22 April 1999

Laurie Richards
Rock Engineering Consultant

MAUAO STABILITY ASSESSMENT

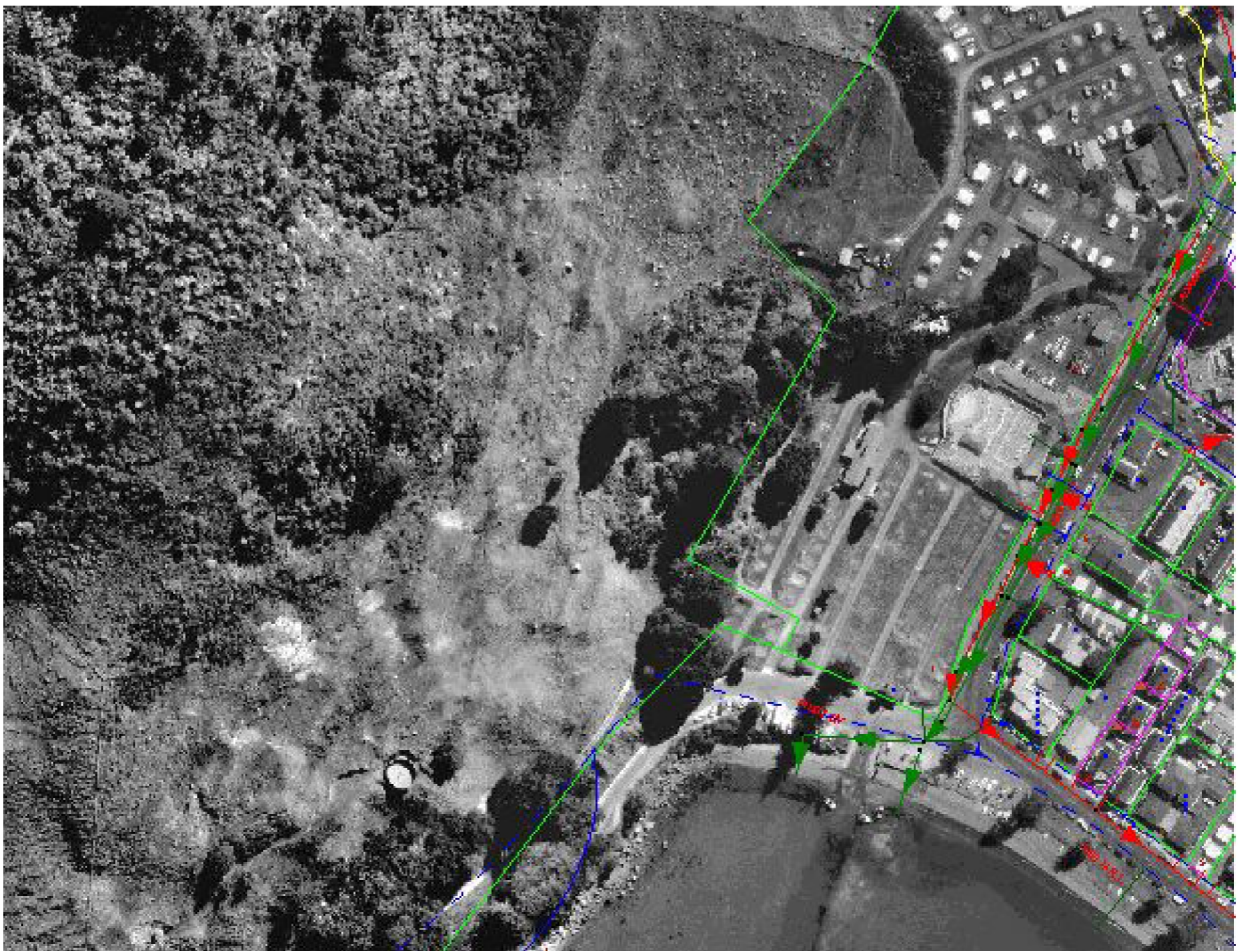
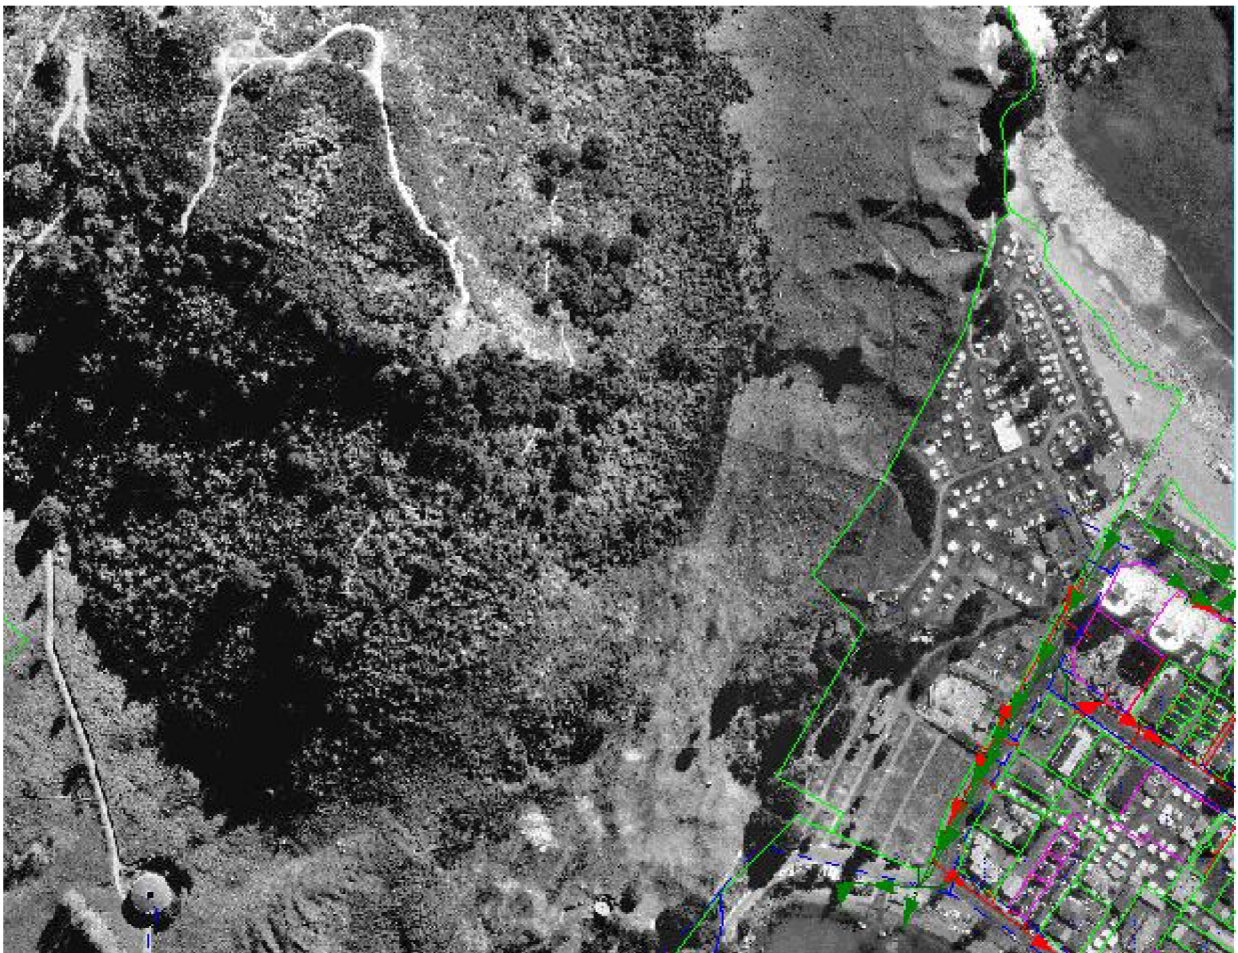
- I have attached the following pictures that maybe of use in displaying the above as well as the Hot Pools and the Motor Camp in relation to the main slip features.
